Meeting Agenda

Historic Zoning Commission

Monday, August 14, 2023

1 ADDITION LEFT ELEVATION
1/8" = 1'-0"

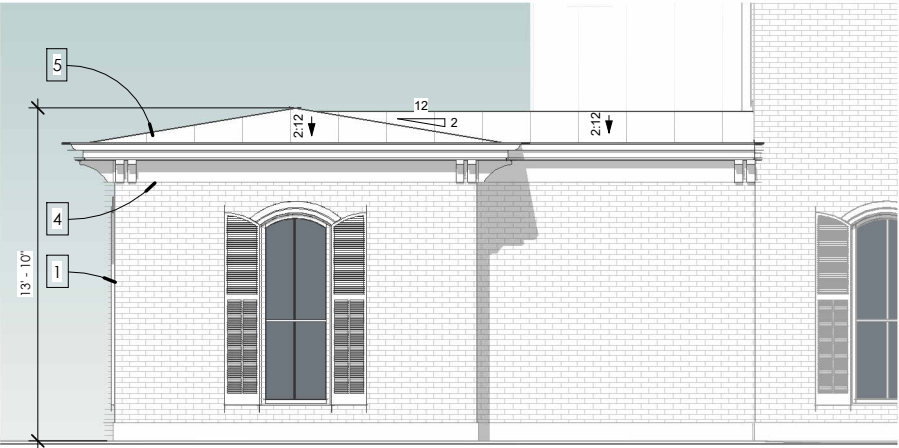
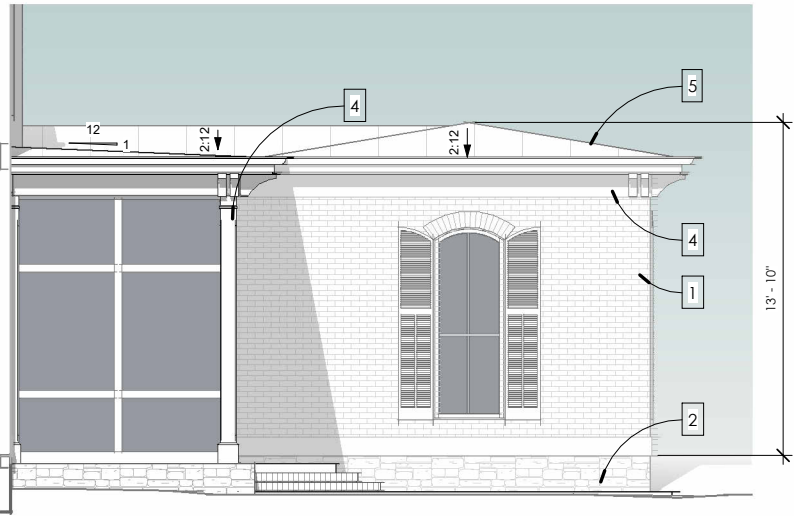
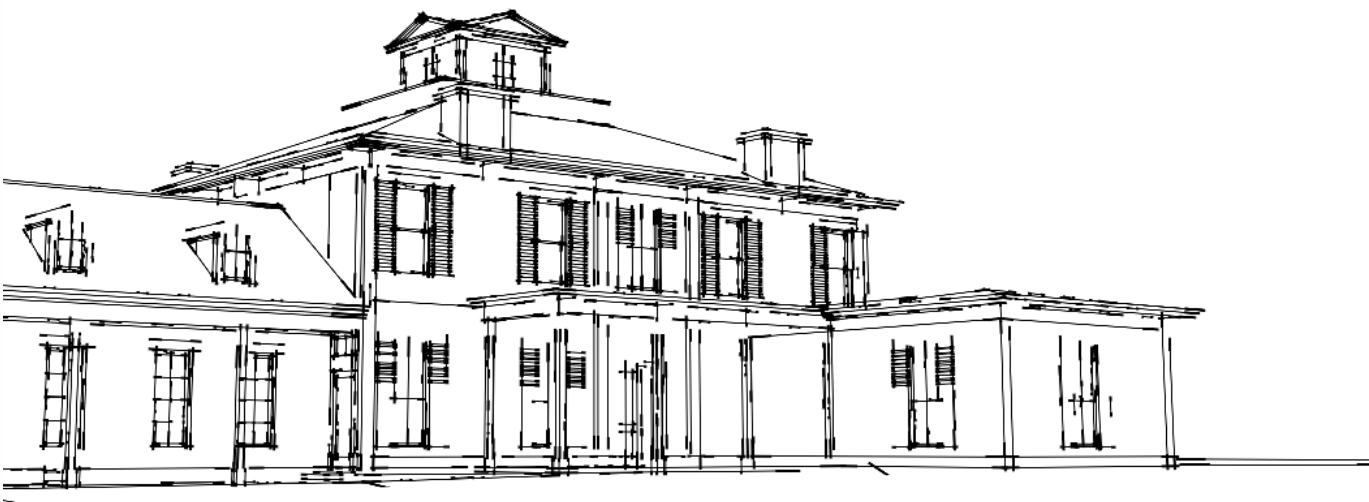
- 1) The double columns on the front porch should be reduced to single columns.
- 2) The wall dormer on the front elevation should be altered so it is further off of the porch roof.
- 3) The windows must have a historic profile and dimensions and consist of either wood or composite material with the appearance of wood. The window specifications must be approved by the Preservation Planner or the HZC prior to the issuance of a building permit.
- 4) The application must meet all the requirements of the City of Franklin prior to the issuance of a building permit.
- 5) Any additional changes to the approved plans must be returned to the Preservation Planner or the Historic Zoning Commission for review and approval.

Ms. Huffer noted that staff would like the applicant to clarify whether the window lights in the left elevation should be consistent with the other windows.

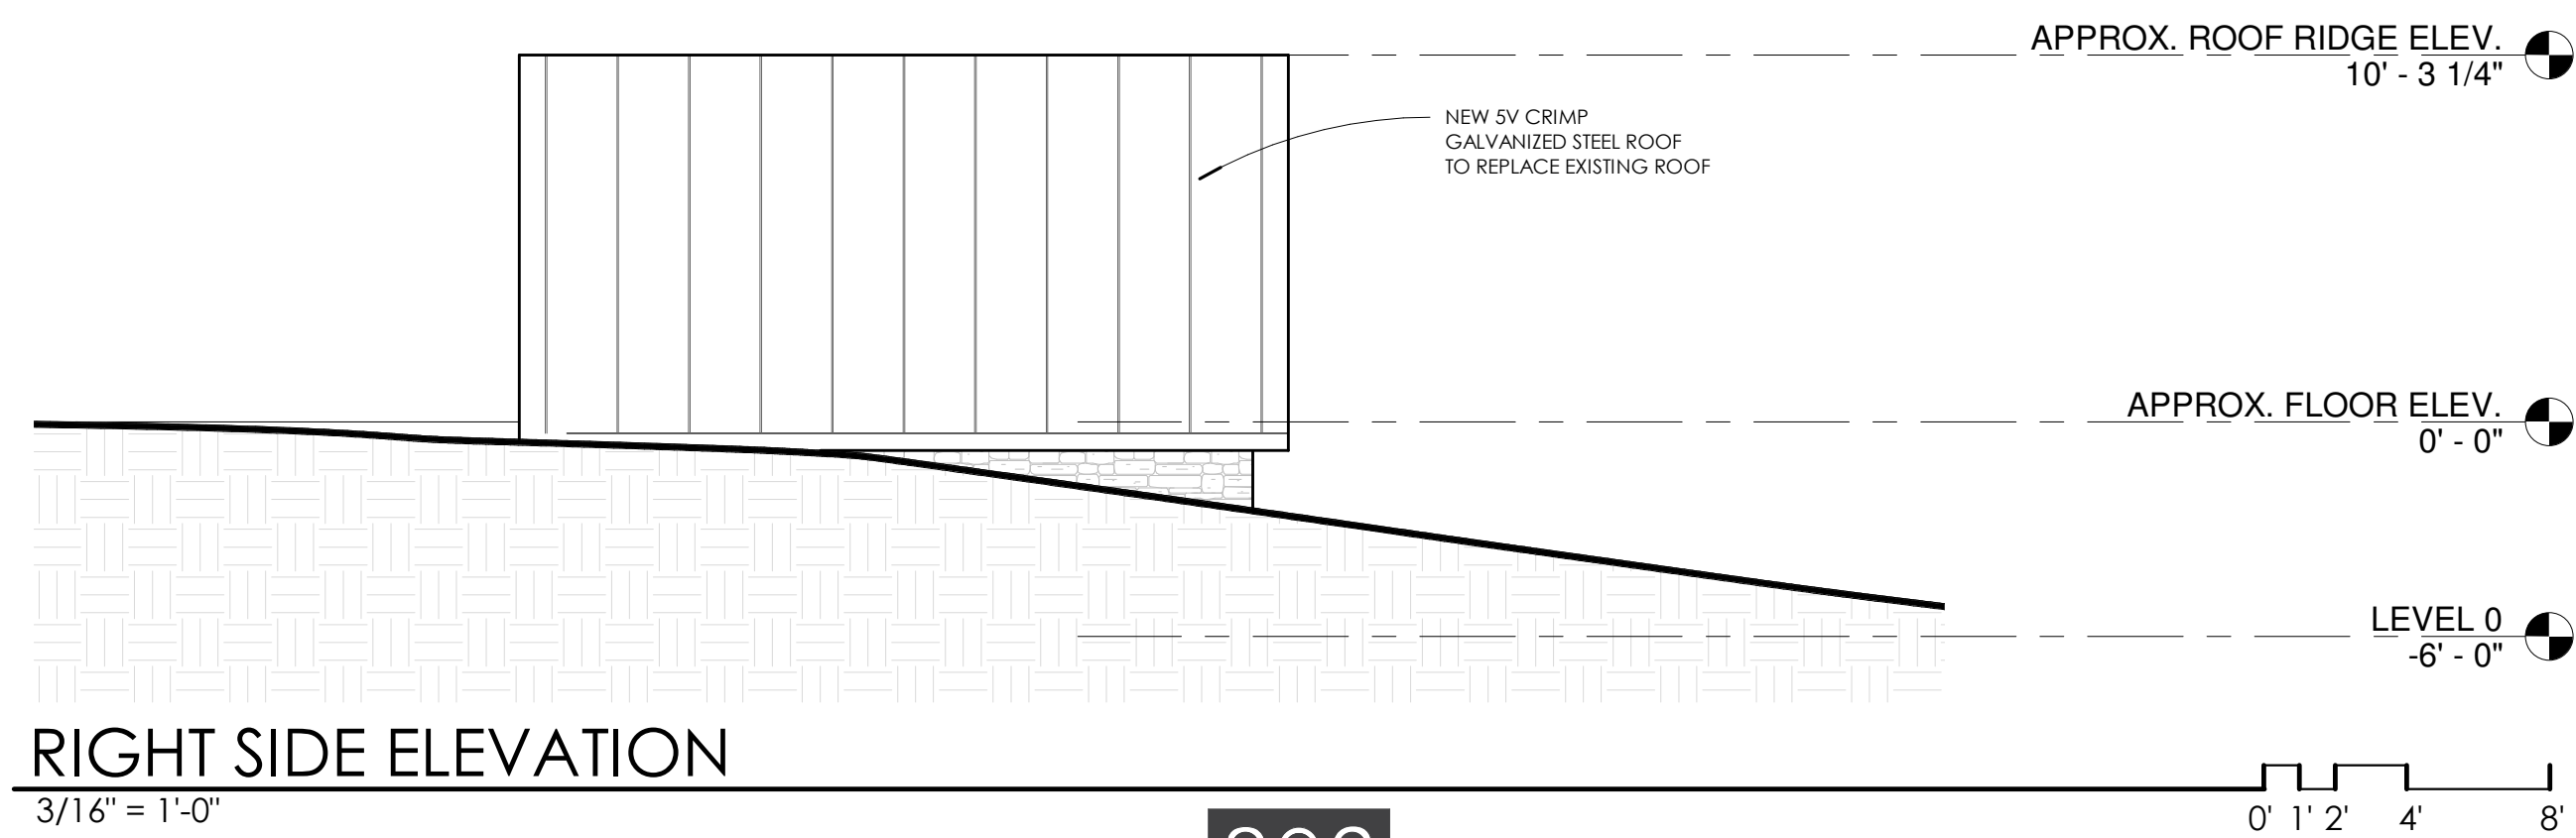
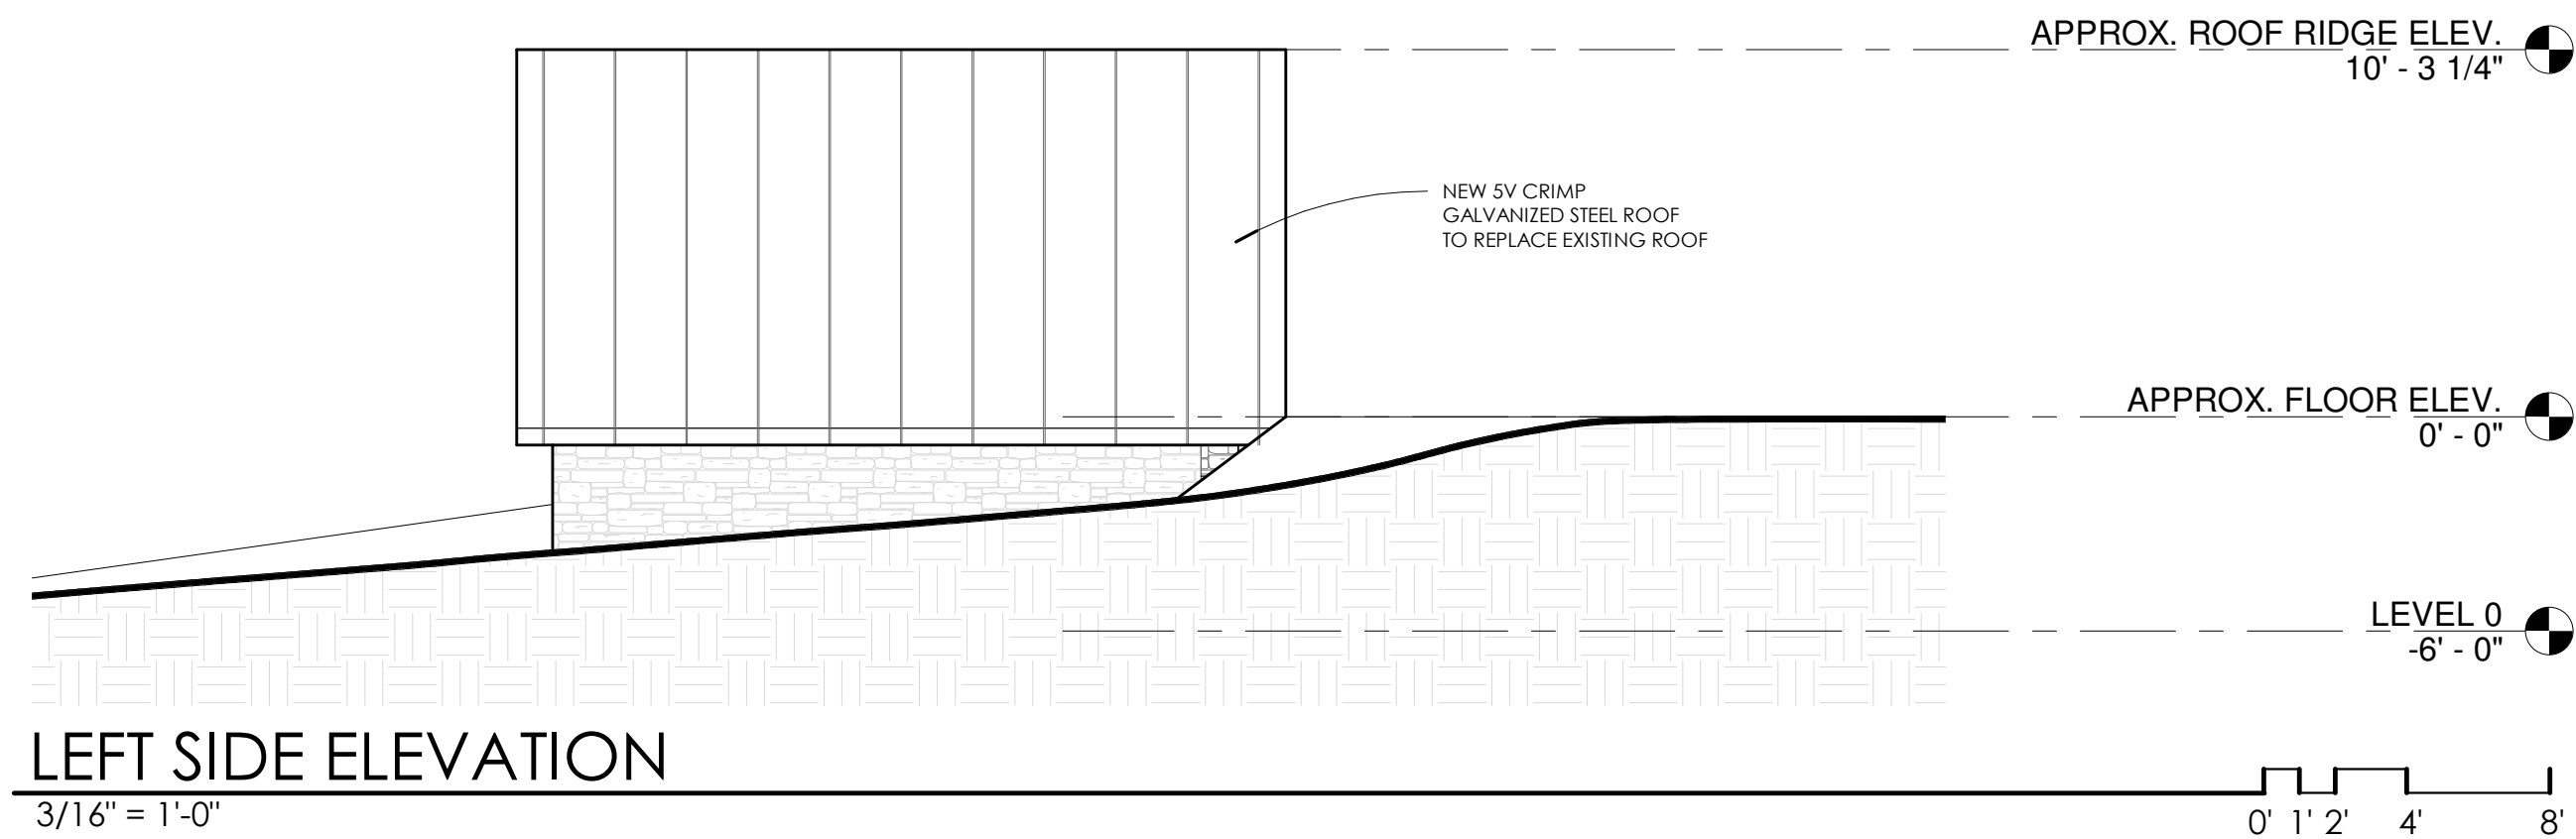
Chair Roberts stated that like the previous item, this house is 31.6 feet in height and with a four-foot elevation of the land, this house will impact the view of Magnolia Hall from Boyd Mill Avenue. Looking at the site plan, houses two, three and four all impact the view of Magnolia Hall.

PROPOSED REAR ELEVATION

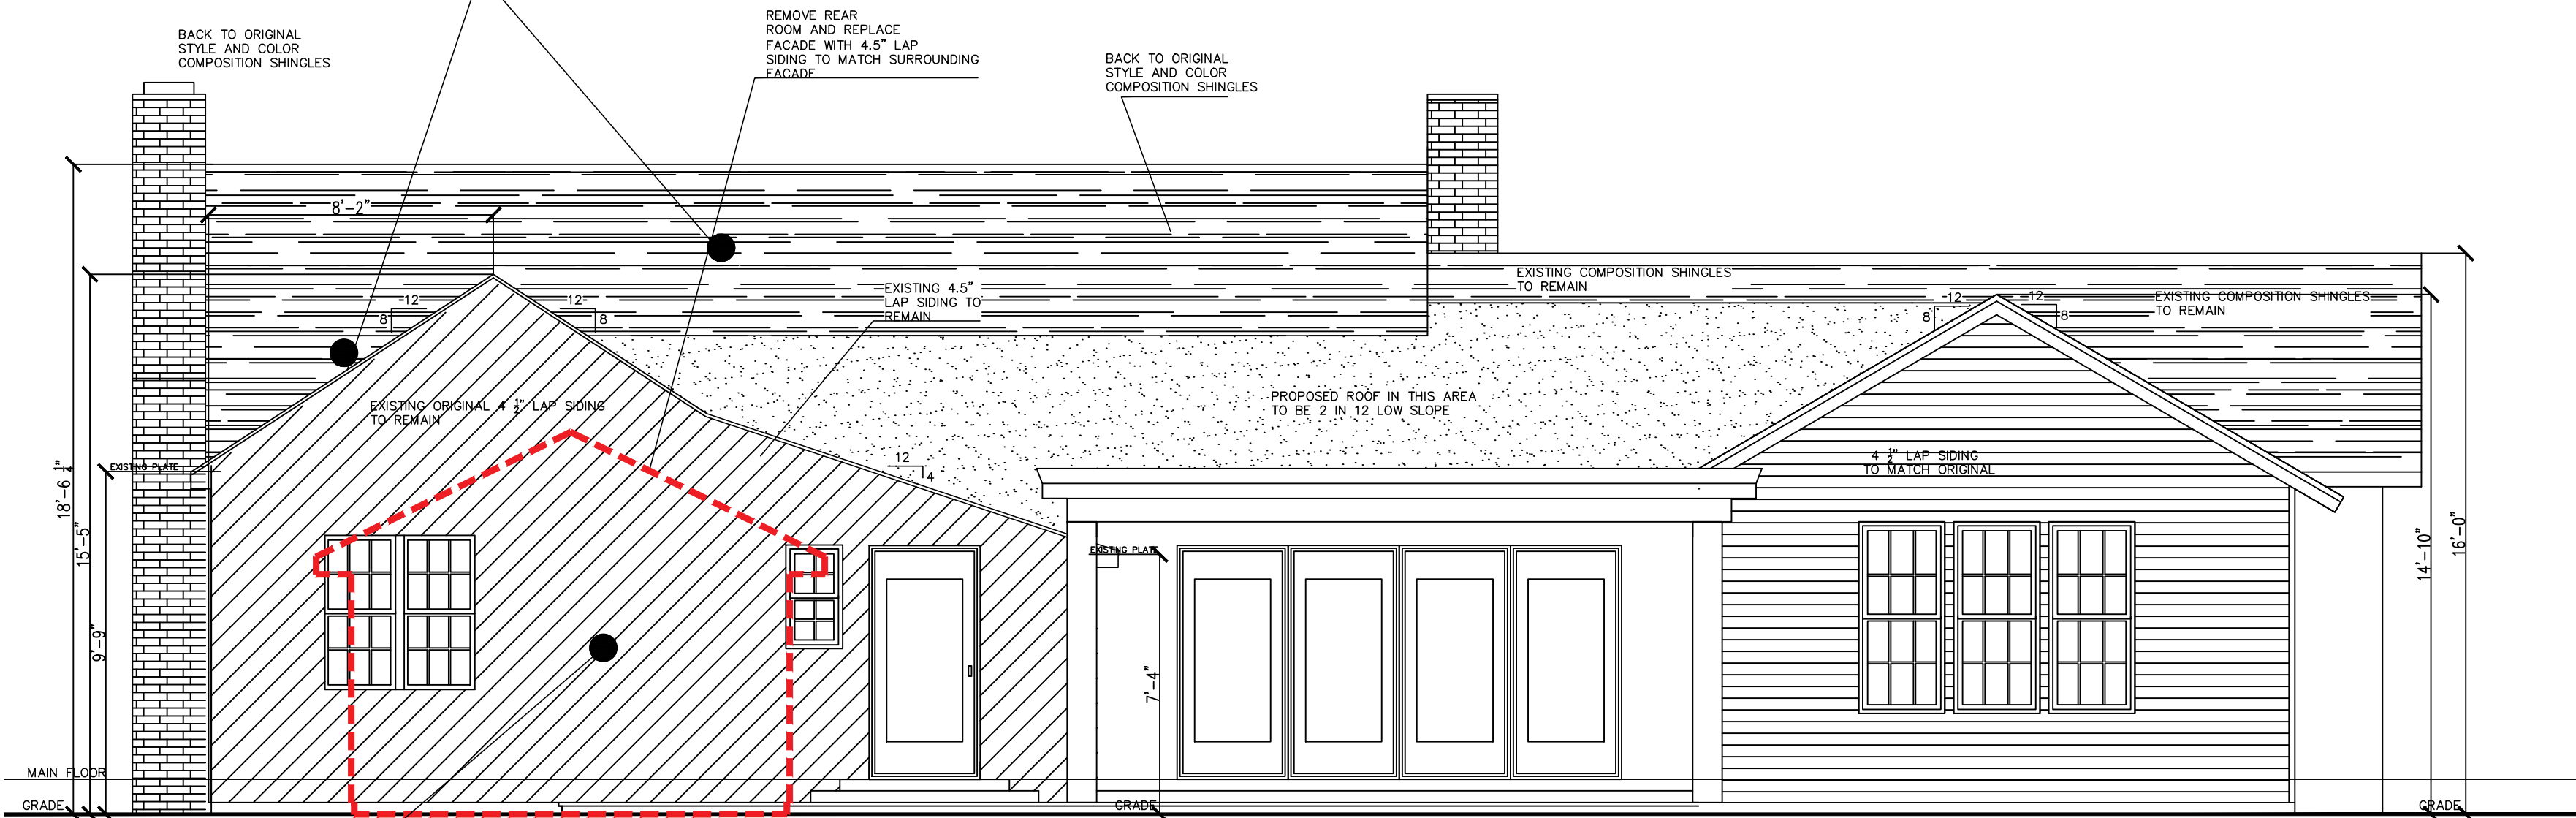
main and other visible facades should remain unaltered," and that "If localized damage occurs, replace the damaged materials only. If partial or wholesale replacement is needed, use materials whose composition and appearance match the historic materials." The applicant has provided a letter from an engineer describing the condition of the original roof; however, this was not part of the original application submittal. Once issues with the roof had been discovered, the applicant should have returned to the Historic Zoning Commission with a modified application addressing the roof concerns. An alternate plan may have been established that would have preserved as much of the roof as possible rather than its entire removal. Entire roof replacement on historic structures is not recommended, however, given the circumstances and the current state of the dwelling, in this instance the application can be supported. The roof must be reconstructed to match what was there previously using materials that match the original.

Commissioner Laster stated that the plans have an April date which would be the original submittal documents. The documents say the roof pitch was 7:12 but there is a note that says the existing roof should be raised 24." Now that the roof has been torn off, what will be the pitch on this part of the roof? Plans would need to be submitted for approval so that the roof can be replaced.

1. The roof must be reconstructed to match what was there previously using materials that match the original.
2. Any additional damage to windows or exterior walls outside of what was approved with the April 2022 COA must be repaired.
3. The application must meet all the requirements of the City of Franklin prior to issuance of a building permit.
4. Any additional changes to the approved plans must be returned to the Preservation Planner or the Historic Zoning Commission for review and approval.

B3 Site Observation

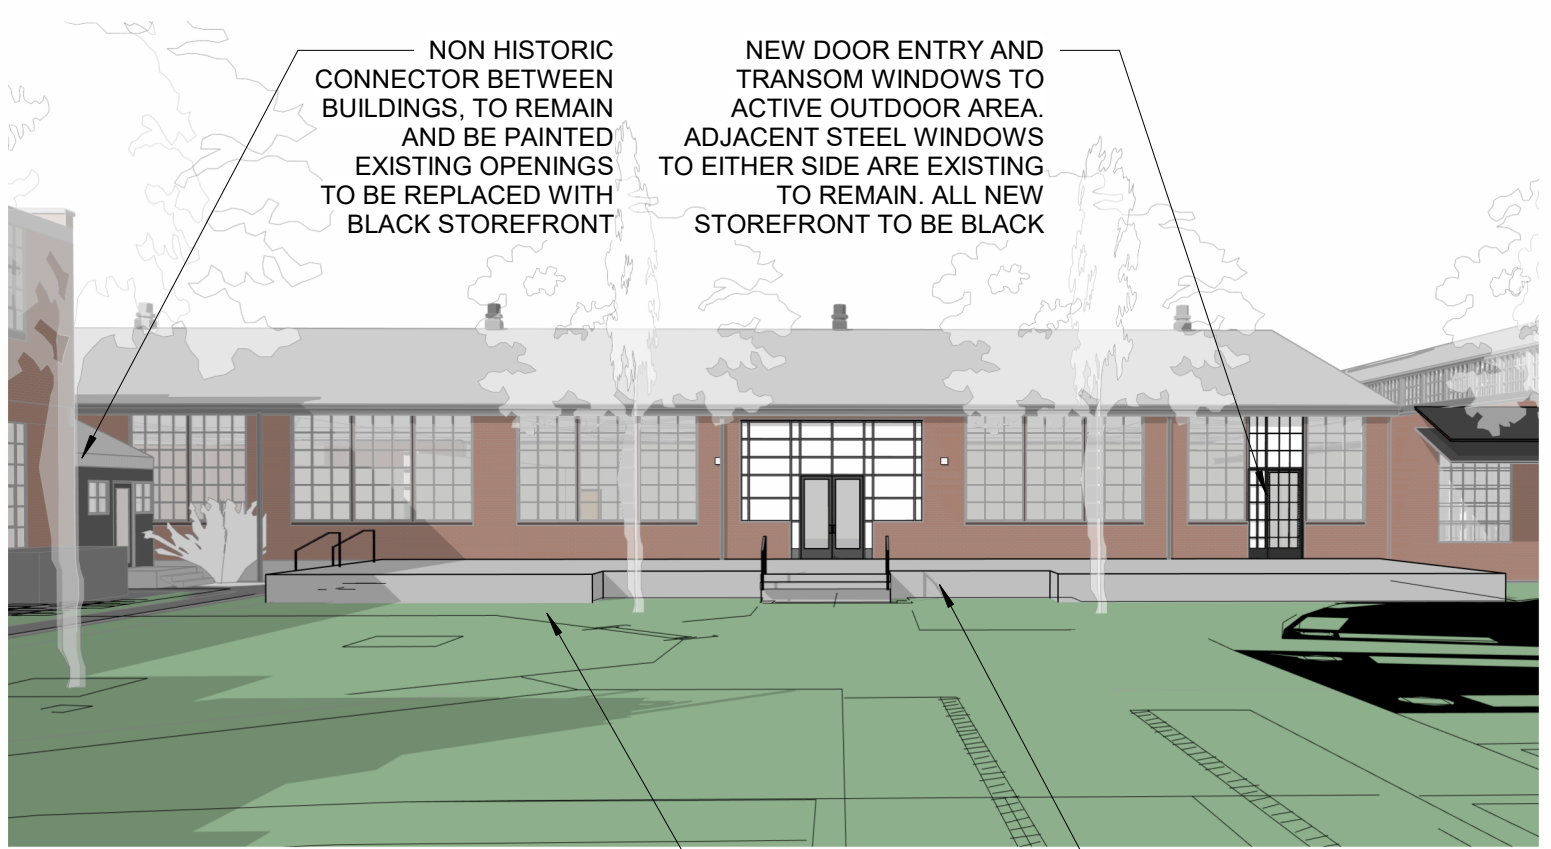
- This opening was unfortunately removed already, and it was an error on the construction team's side.
- They removed it prior to our assessment for the following reasons (assuming we would need to remove it to support a steel door):
 - In this location, the weight of the steel doors could not be supported within the existing window frame with some sort of channel support due to the small amount of wall present to anchor to.
 - They needed the top and bottom of the wall (this is a large opening) in order to support the weight of the door. The weight of a steel door compared to the weight of a storefront door is significantly different. Given the superior aesthetic of the steel door, we have been trying to use those where possible instead of aluminum storefront.
